PCI-SIG ENGINEERING CHANGE NOTICE

TITLE:	Extended Message Data for MSI
DATE:	May 10, 2016
AFFECTED DOCUMENTS:	PCI Local Bus Specification Revision 3.0 PCI Express® Base Specification Revision 3.1 Single Root I/O Virtualization and Sharing Specification Revision 1.1
SPONSORS:	Jim Panian, Qualcomm Technologies Inc. Joe Cowan, Hewlett Packard Enterprise

Figure 6-9: MSI Capability Structures

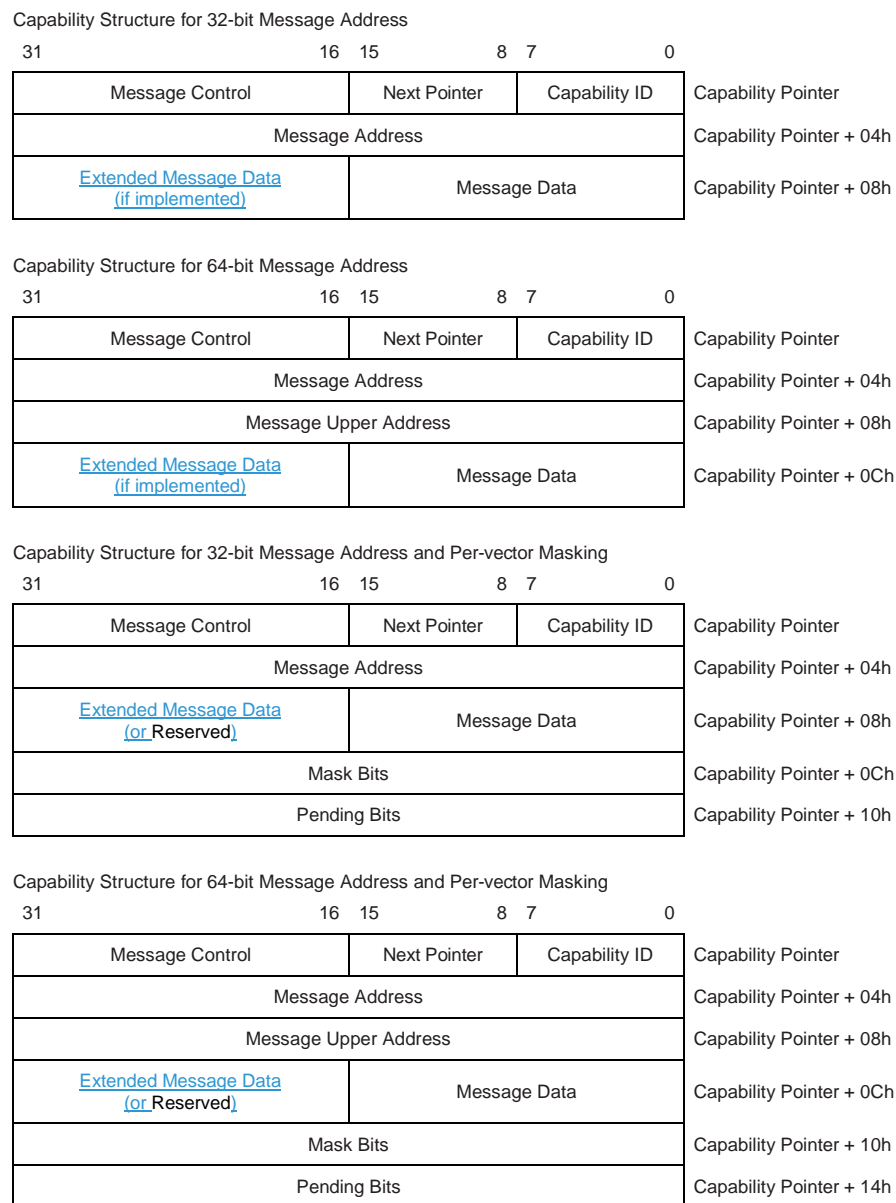
Change Section 6.8.1, MSI Capability Structure, page 232 as follows:

To request service, an MSI function writes the contents of the Message Data register, [and if enabled, the Extended Message Data register](#), to the address specified by the contents of the Message Address register (and, optionally, the Message Upper Address register for a 64-bit message address). A read of the address specified by the contents of the Message Address register produces undefined results.

A function supporting MSI implements one of four MSI Capability Structure layouts illustrated in Figure 6-9, depending upon which optional features are supported. If a function supports 64-bit addressing (DAC) when acting as a master, the function is required to implement 64-bit addressing.
